DATE: NOVEMBER 13, 2017
ADDENDUM NO.: 1
BID NO.: FWC 17/18-05
BID TITLE: GULF SENTRY VESSEL REPAIRS
UPDATE: QUESTIONS & ANSWERS

ADDENDUM NO. 1

Item #1: Questions and Answers

Answer #11: a. **Exterior of superstructure**

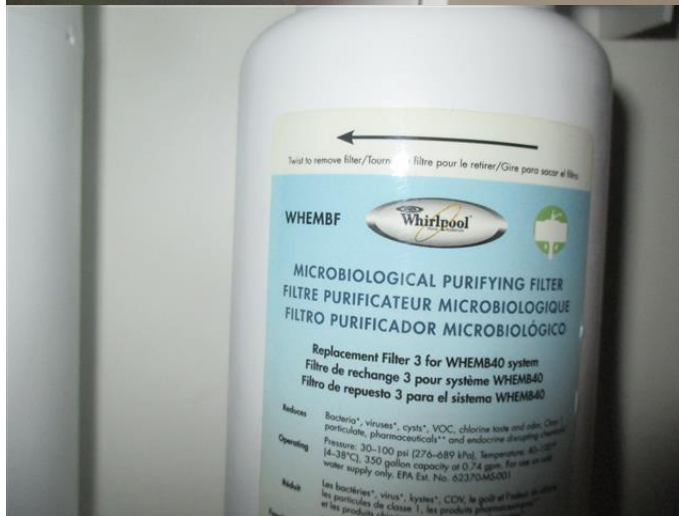
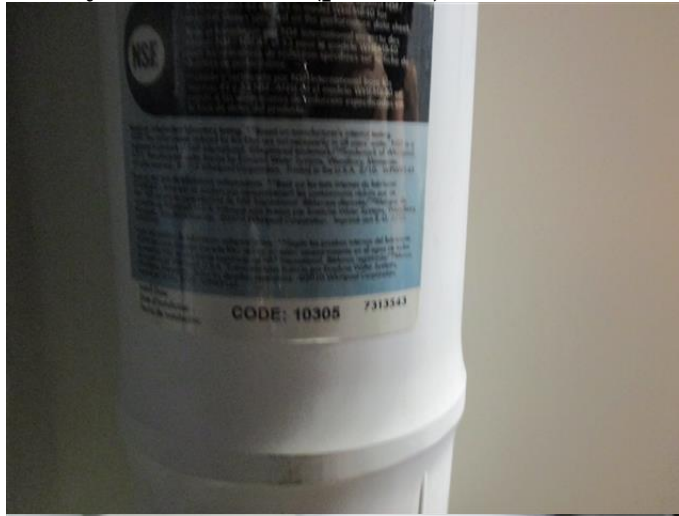
Question #11: Can the following pictures be provided?
